F28450  
 JANE PURSLOW  
 GARLAND DESIGN  
 THE GROVE  
 WARREN PARK  
 KINGSTON UPON THAMES  
 KT2 7HX  
 1 OF 8

**From:** Dawn Garland  
**Sent:** 04 October 2023 10:18  
**To:** Fulham Branch (Mr Carpet) <[fulhambranch@mrcarpetlondon.co.uk](mailto:fulhambranch@mrcarpetlondon.co.uk)>  
**Cc:** Mark Robinson <[mrdaarc@icloud.com](mailto:mrdaarc@icloud.com)>  
**Subject:** Re: The Grove, Warren Park

Please find attached the marked up plans for the carpet.

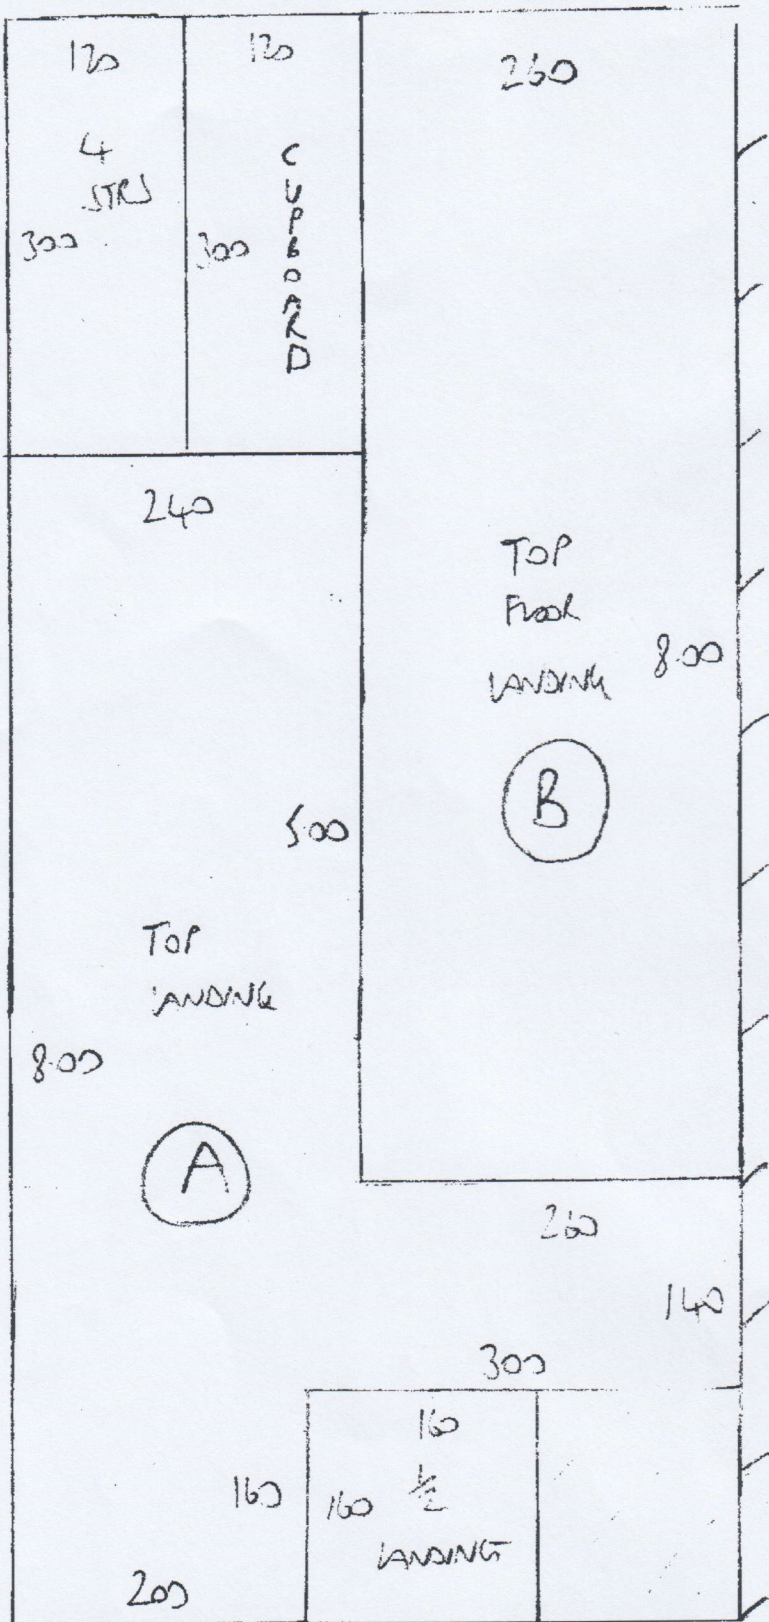
- 4.30 ✓
- 11.00 ✓
- 10.30 ✓
- 10.30 ✓
- 6.70 ✓ MB
- 5.80 ✓ GB

$48.40m \times 5.00m = 242m^2$

Marble ✓

RU 101

JANE  
PURSLOW  
F28450  
GALLUP DESIGN  
THE GRAY  
WAREHOUSE  
KT2 74X

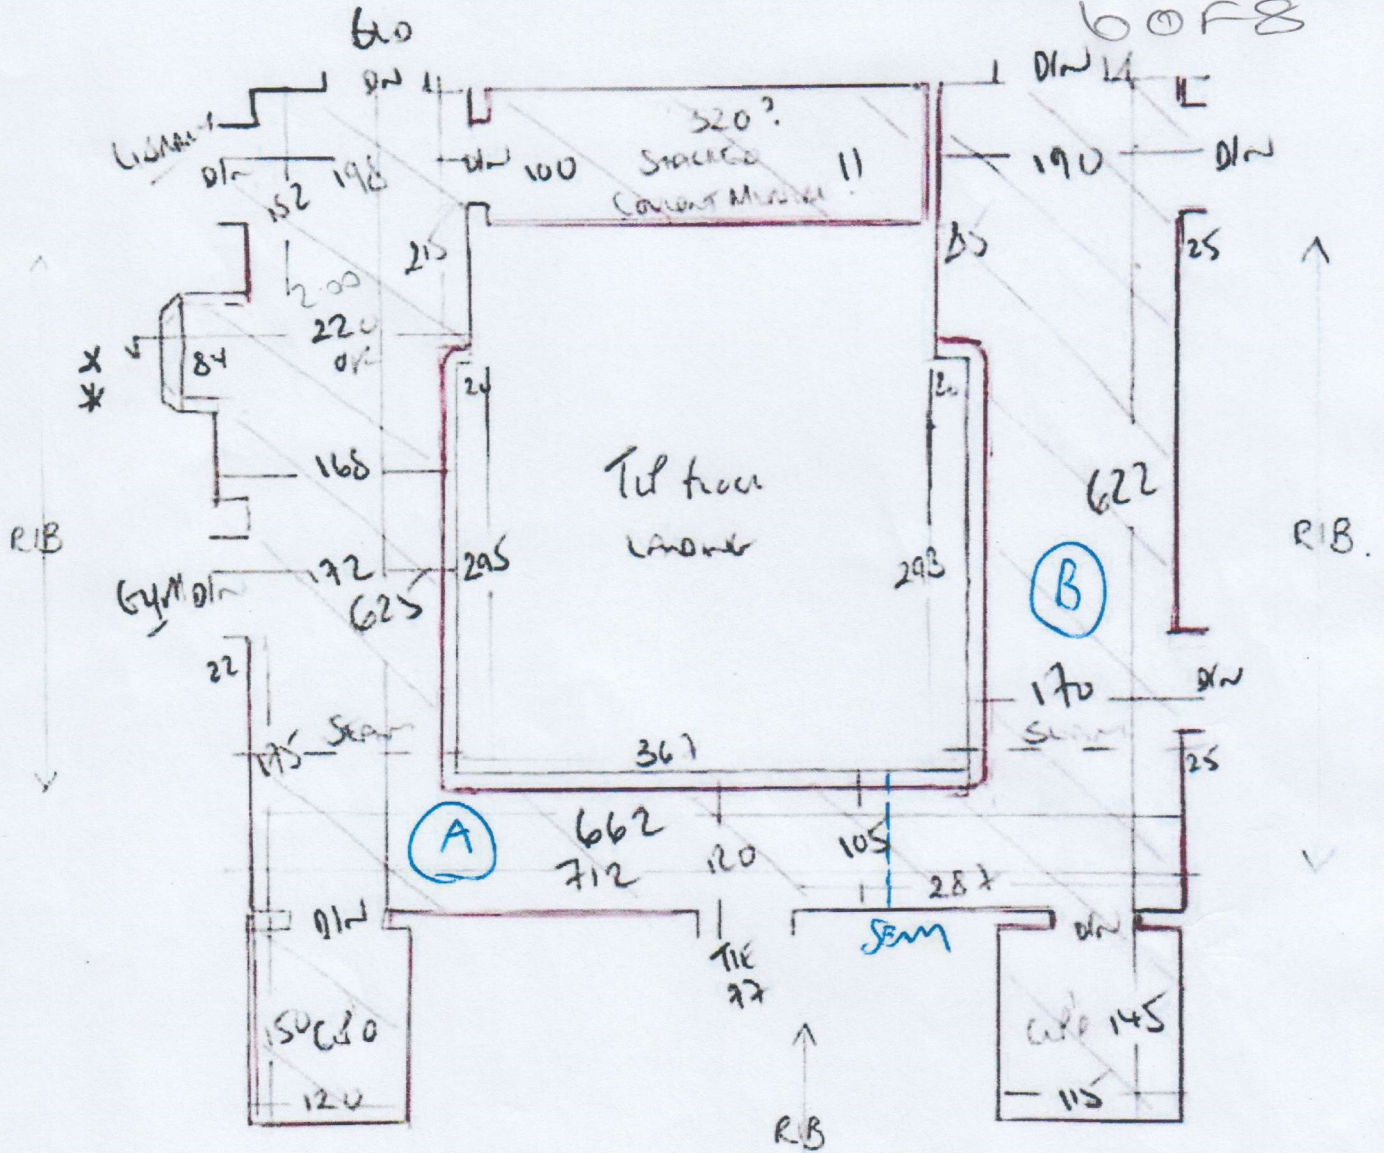
RIB  
TO MATCH LANDING  
DIRECTION

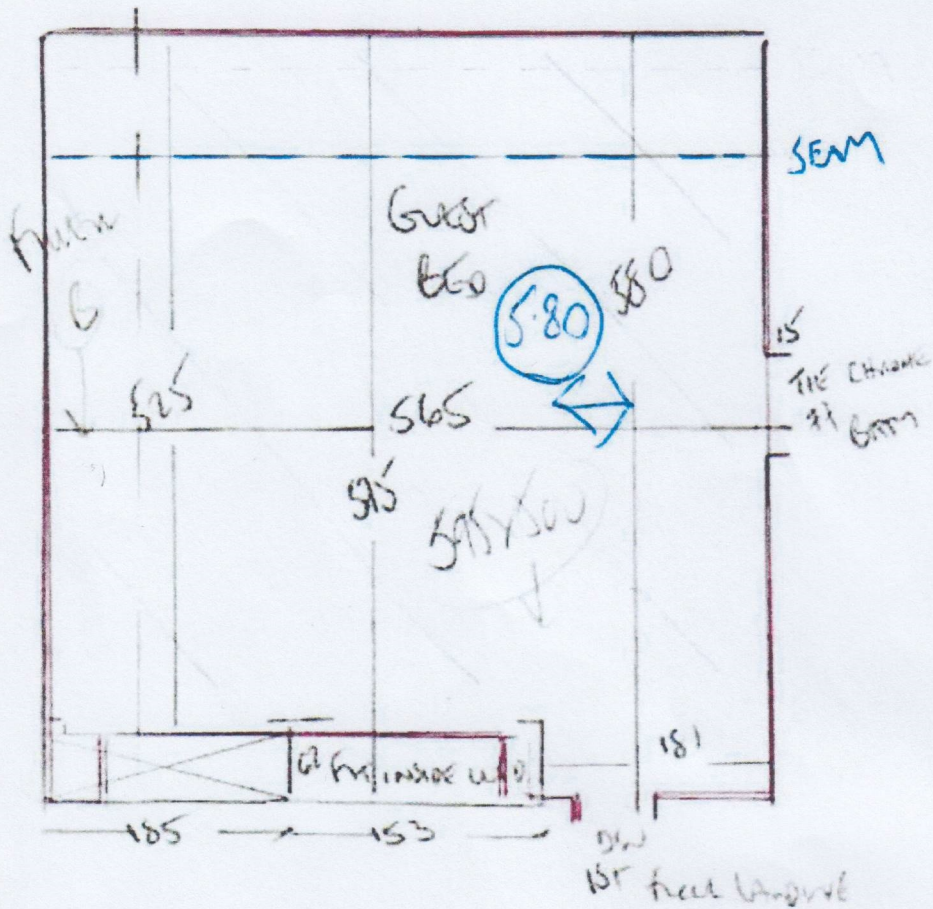
75mm  
45 x 87 \*  
To 1st floor  
LANDING
